Memorandum

June 17, 2008

TO: Columbia River Crossing Task Force
FROM: CRC Pedestrian and Bicycle Advisory Committee (PBAC)
SUBJECT: PBAC Recommendations for World Class Pedestrian and Bicycle Facilities

PBAC Proposed Pedestrian and Bicycle System for Replacement Bridge

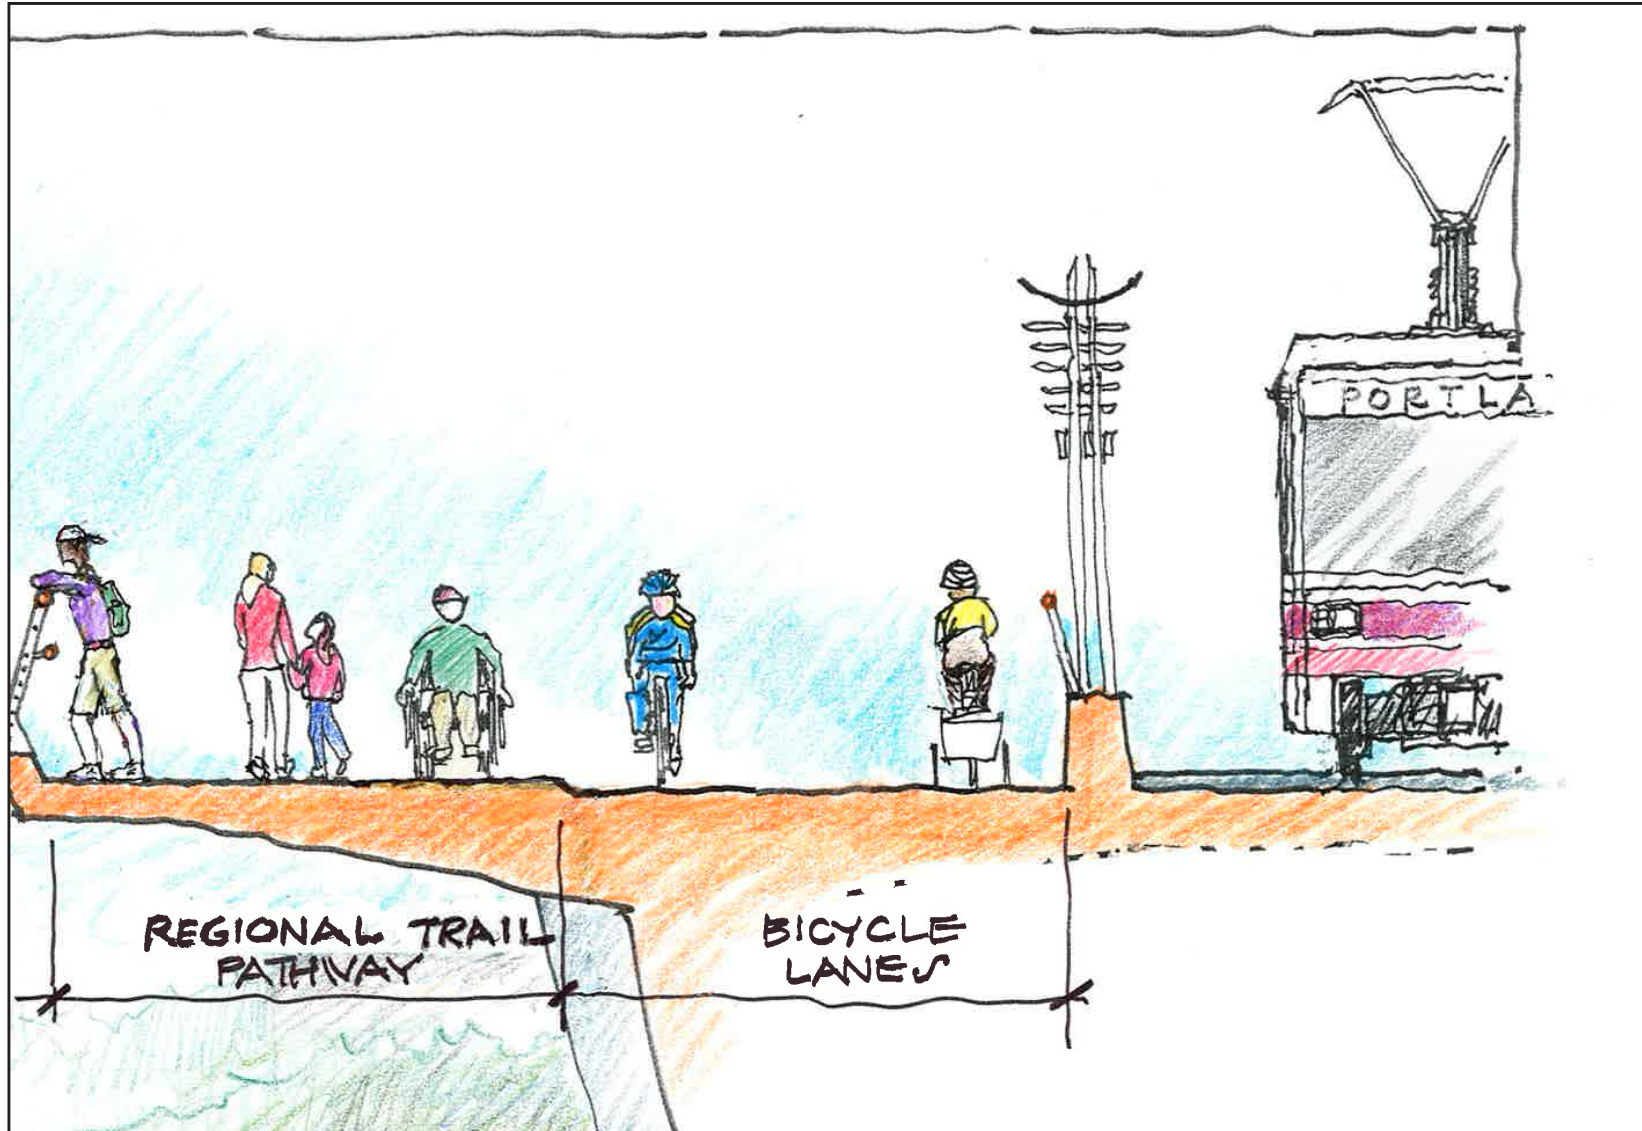
- The overall pathway on the western bridge (adjacent to the transit guideway) must provide separation between recreational users and higher speed bicycle users. To provide this separation, a 12-foot wide regional trail should be provided adjacent to, and to the west of, a pair of six-foot wide bicycle lanes (see attached rendering). These recommended widths are exclusive of potentially needed shy distances, i.e., free and clear of poles and other obstructions to enable safe pedestrian and bicycle movement (a summary of agency standards for multiuse paths, sidewalks and bike lanes is attached).

The regional trail would accommodate pedestrians, persons with disabilities, seniors, families with children, tourists, roller-skaters, and recreational bicycle riders. The adjacent bicycle lanes would be used by bicycle commuters and other faster-moving bicyclists. The regional trail would be at a slightly higher level than the bicycle lanes, but bicyclists in the bicycle lanes would be able to access the trail. Different paving treatments and/or patterns should differentiate the regional trail and the bicycle lanes.

- In addition to the combined regional trail and bicycle lanes on the western bridge, an eight-foot wide sidewalk should be provided on the eastern bridge (the bridge that would serve the northbound traffic lanes) across both the Columbia River and the North Portland Harbor. The sidewalk across the North Portland Harbor would touch down on Hayden Island and use surface street sidewalks to connect to the sidewalk across the Columbia River.
